NEW 2ND BRIGADE BASE
KIRKUK, IRAQ

SIGIR PA-06-041
APRIL 20, 2006

SUBJECT: Report on Project Assessment of the New 2nd Brigade Base, Kirkuk, Iraq
(Report Number SIGIR-PA-06-041)

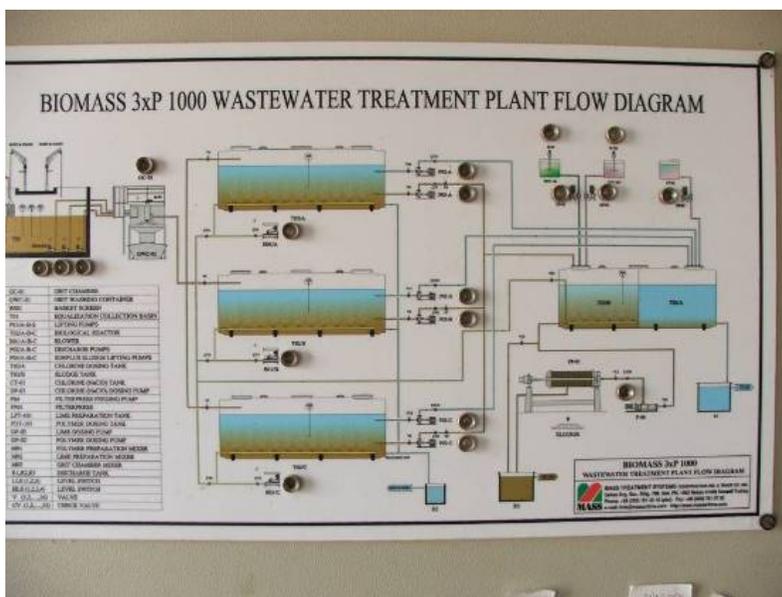
The storm water management system and sewer system design and installation was complete at the time of the assessment. Since these systems were underground, we did

not examine them during the assessment; however, what appeared to be storm water drainage system manhole covers were apparent and drainage did not appear to be a problem even with the wet weather that occurred prior to the assessment. Photos reviewed from the construction and installation of these systems appeared adequate to meet the specifications of the contract.
